SUBJECT: VOIDED APPLICATION

We request approval for compaction of radioactive waste at Monsanto Co. Research Laboratories, 700 Chesterfield Village Parkway, St. Louis, Missouri, 63198 by amendment 24 to our NRC License 24-01113-14. This license is one of three held by Monsanto Co. on the Chesterfield Village Parkway site. All three licenses will use the same compactor. The waste generated by the different licenses are packaged and will be compacted separately.

RADIOACTIVE WASTE COMPACTION

ITEMS AND RESPONSES

FIGURE 1.

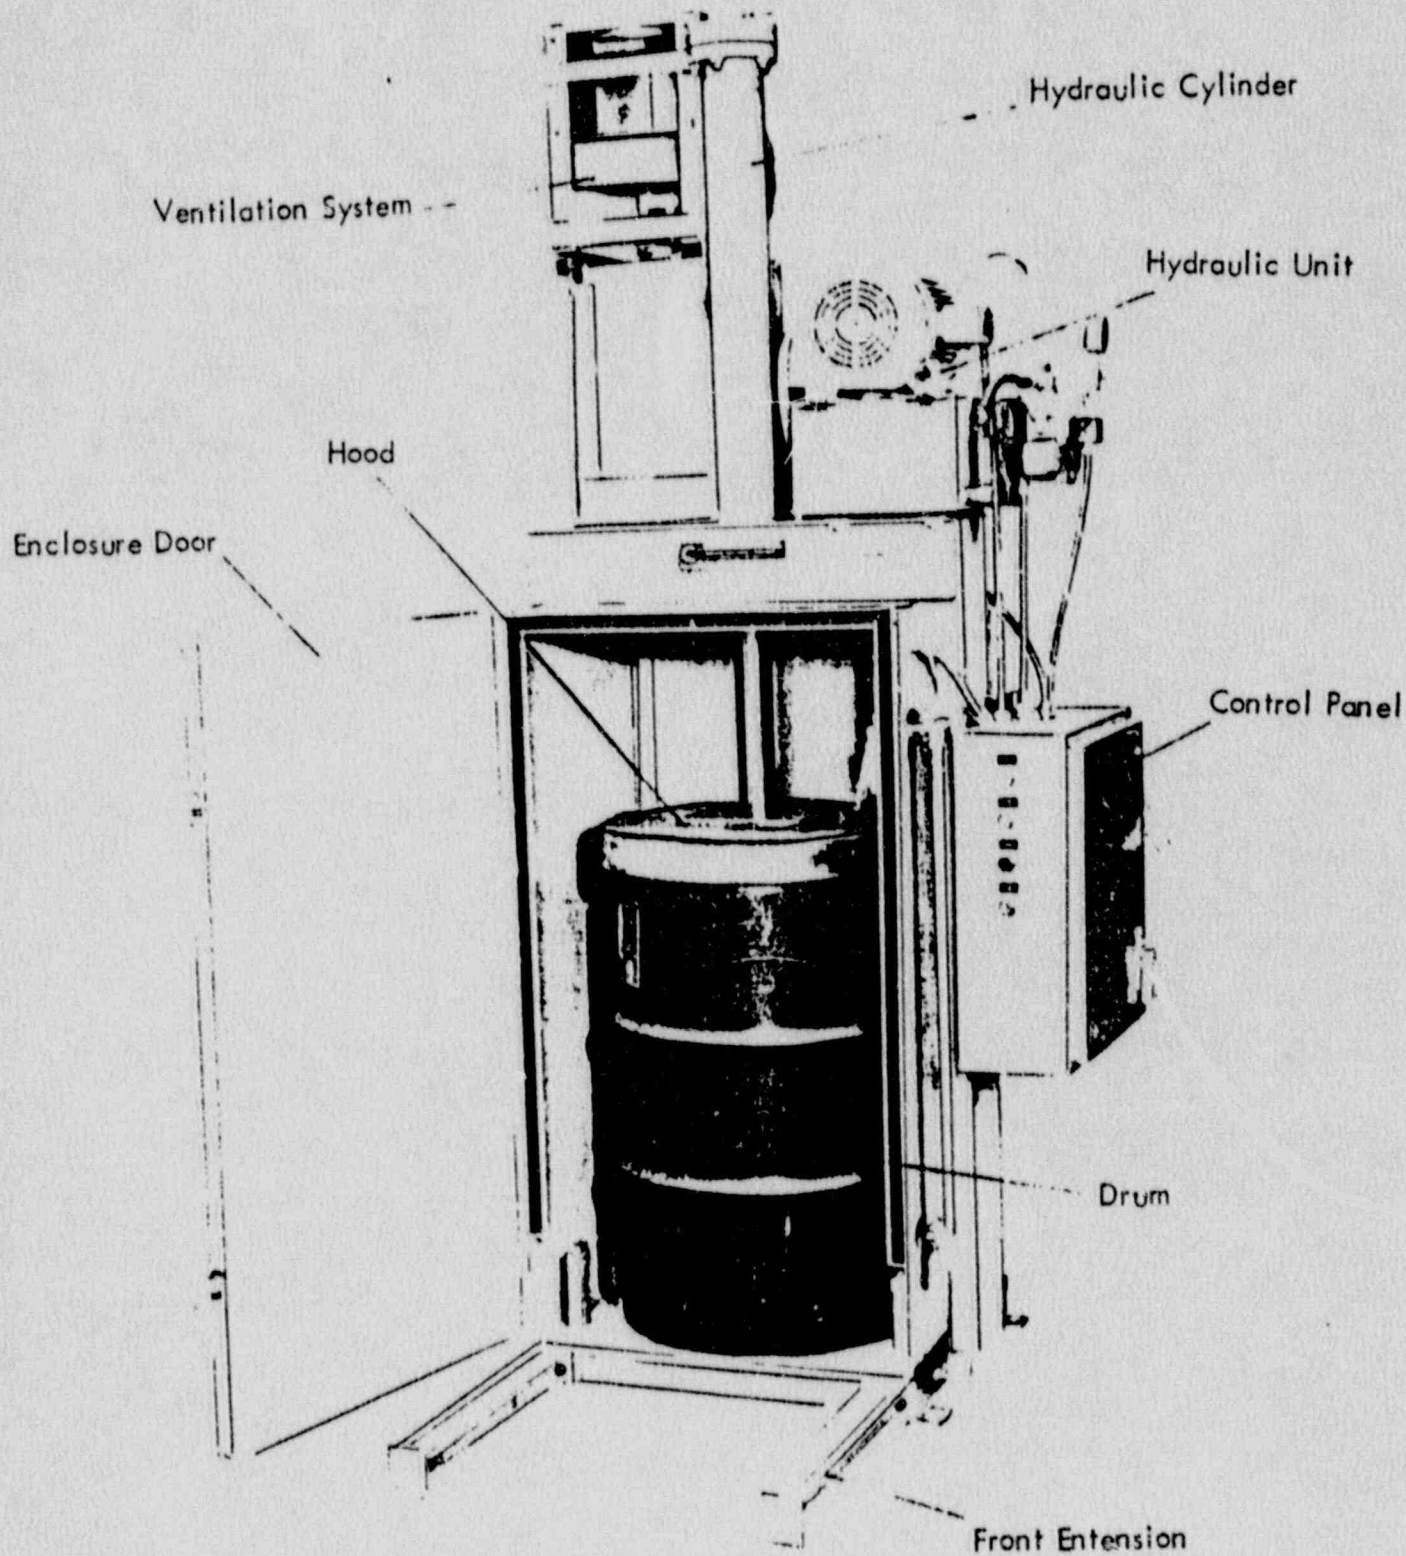
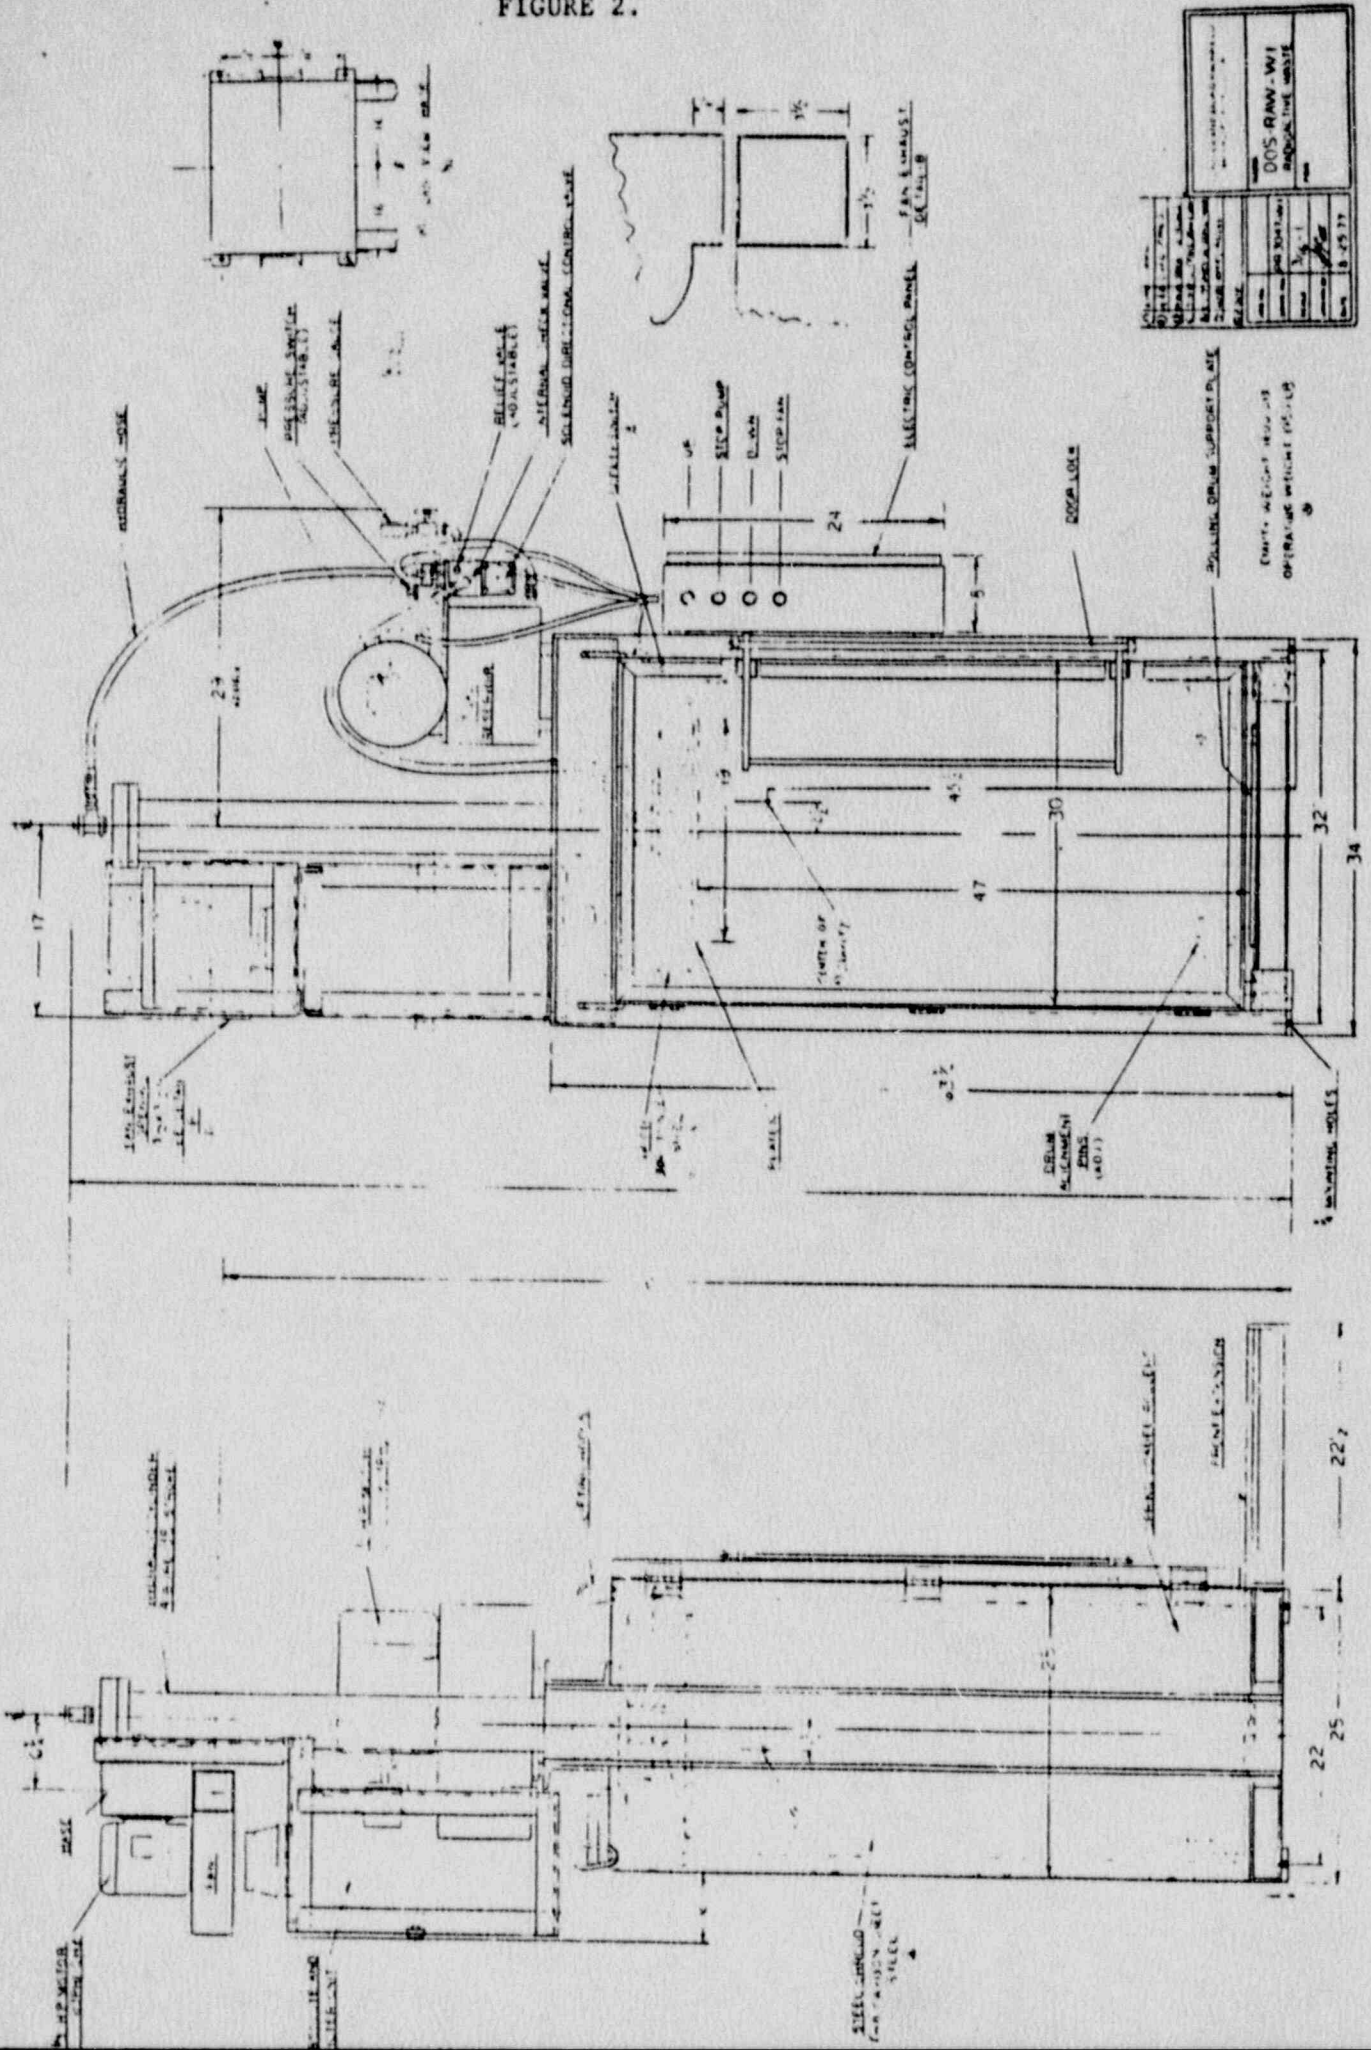
The type of compactor you will use. If it is the Consolidated Bailing Machine Company's Model DOS-RAW-W1, please specify this in your response. If you will be receiving another compactor, please specify the manufacturer's name and model number as well as submitting a diagram of the device.

A description of the ventilation and filtering system used in conjunction with the compactor. The system must be capable of handling the type of radionuclides in the waste to be compacted (e.g., charcoal filter for iodines). Please include a description of your procedures for monitoring filters and filter blockage.

The compactor is from Consolidated Bailing Machine Co., Model DOS-RAW-W1. It is equipped with a Flanders model P-007-C-04-00N LCNZ Z72 209C Nuclear Grade HEPA filter and before compaction of radioiodines with a 2V-N63-G16 charcoal filter. Specifications and diagrams of the compaction system as supplied by the vendor are attached. (Figures 1 and 2 and Attachments 1, 2 and 3).

As seen in Figures 1 and 2, the compactor is equipped with an exhaust fan system. The fan draws air through a HEPA filter and a charcoal filter at a rate of 350 cubic feet per minute from the drum compartment. The filtered exhaust air is ducted to a stack that extends four feet above the roof of the building. A magnehelic gauge, installed by the manufacturer, is between the exhaust fan and the HEPA filter for measuring the suction applied to the filter. The pre-filter and HEPA will be replaced before the pressure drop across the filter, as measured by the gauge, has increased to the manufacturer's recommended limits. Attachment 2 describes the charcoal filter used on the compactor. At our request, Mr. R.K. Holloman of Flanders Filters, Inc. furnished us further information so we could determine when to change the filter. Mr. Holloman stated that the charcoal filter (2V-N63-G16) holds seventy-five pounds of charcoal with a capacity for I-131 of 100 micrograms for a gram of charcoal. This capacity calculates to 3.4 grams of iodine for the filter. The approximate specific activity of the radioiodine used at our Research Site is 17 curies per milligram. Since the possession limit of all licenses located at this site for radioiodine is less than one curie, we will never exceed the capacity of the filter. We will, however, inspect the filter routinely to determine any physical damage or blockage.

FIGURE 3.

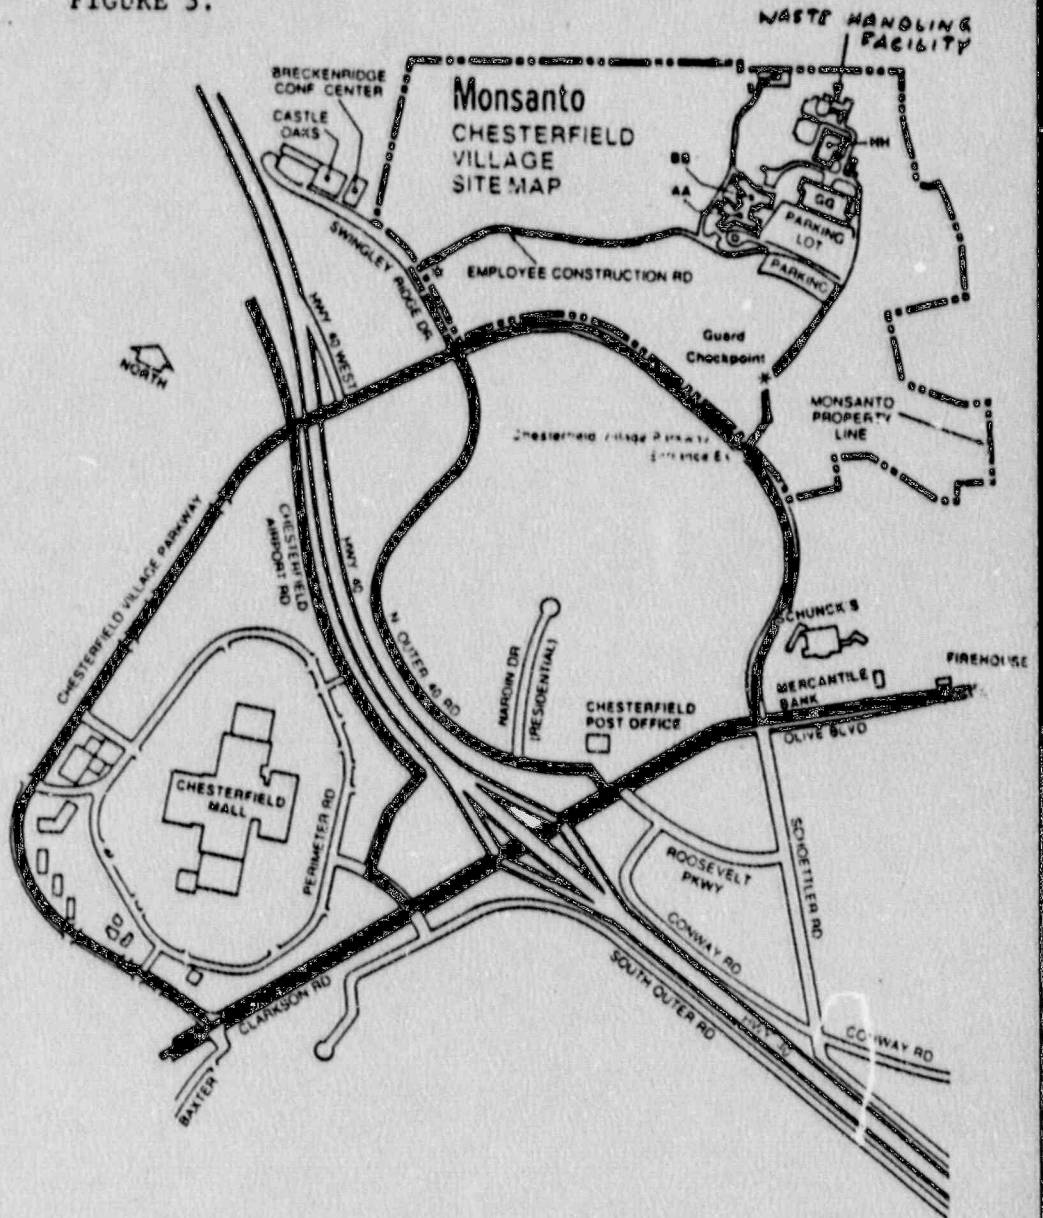
Specify the location of the compactor at your facility and describe your methods of controlling access into this area during compaction. Also describe the area where drums will be stored prior to shipment.

The compactor is installed in the Waste Handling Facility (WHF) of Monsanto Research, Chesterfield Village. The location of the WHF is shown on Figure 3. The compactor is located in the building at the WHF as shown on Figure 4. This building is kept locked. During compaction, stanchions and chain with warning signs ("Caution, Radioactive Materials") are placed around the working area of the compactor, which include the compactor and any materials brought to be compacted. Radioactive materials are stored in a building immediately adjacent to the compaction building. The storage area is roofed, fenced, posted and locked. In addition to WHF security, the entire Chesterfield Village Research Site is a secured site with a guard force on duty at all times.
